Access Compliance Report

(Curb Ramps)

Intersection ID: 11480	Main Street: N_CEDAR_ST	Cross Street: W_5TH_ST	Location:	S
ADA ID: 02FB7603E7C8	Ramp Type: PerpDiag	Initial Pass/Fail: Fail	Overall Compliance: No	Severity Score: 25
Codes/Mitigation Info/Possible Solution		Field Measurements/Component Compliance

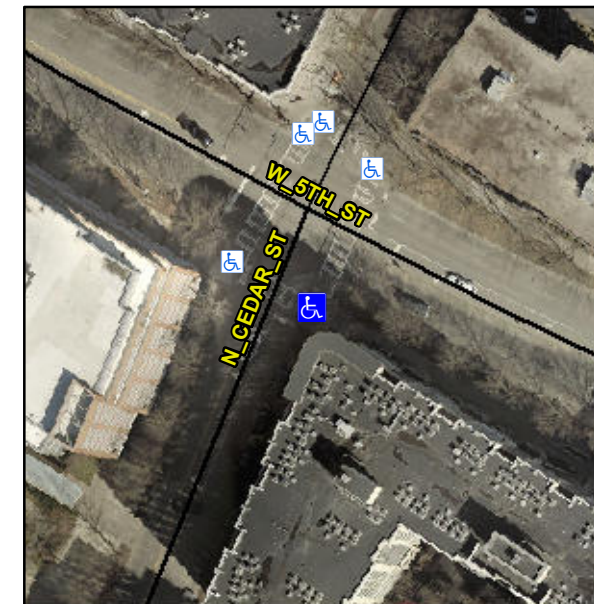
Not Found, R304.5.3

Compliance	Description	Data	Compliance	Description	Data
N/A	Ramp Length (in)	140.0	Yes	Ramp Slope (%)	7.5
Yes	Ramp Width (in)	86.0	No	Ramp XSlope (%)	7.0
N/A	Flare Type LT	N/A	N/A	Flare Type RT	N/A
N/A	Flare Slope LT (%)	N/A	N/A	Flare Slope RT (%)	N/A
N/A	Flare Traversable LT?	N/A	N/A	Flare Traversable RT?	N/A
N/A	Landing Length (in)	N/A	N/A	DWS Provided?	N/A
N/A	Landing Width (in)	N/A	N/A	DWS Contrast?	N/A
N/A	Landing Slope (%)	N/A	N/A	DWS Length (in)	N/A
N/A	Landing X Slope (%)	N/A	N/A	DWS Full Width?	N/A
N/A	Landing Curb? (Y/N)	N/A	N/A	DWS Offset (in)	N/A
N/A	Shared Landing?	N/A			
N/A	Gutter Ponding?	N/A	N/A	Gutter Slope (%)	N/A
N/A	Gutter Lip Ht (in)	N/A	N/A	Gutter X Slope (%)	N/A
N/A	Painted X Walk1?	Yes	N/A	Painted X Walk2?	Yes
	X Walk 1 Direction	To NE		X Walk 2 Direction	To NW
N/A	X Walk 1 Width (in)	105.0	N/A	X Walk 2 Width (in)	107.0
	X Walk 1 Slope (%)	2.5		X Walk 2 Slope (%)	4.3
	X Walk 1 X Slope (%)	2.6		X Walk 2 X Slope (%)	3.0

Remove & Replace Curb Ramp With Two New Directional Ramps or Equivalent.
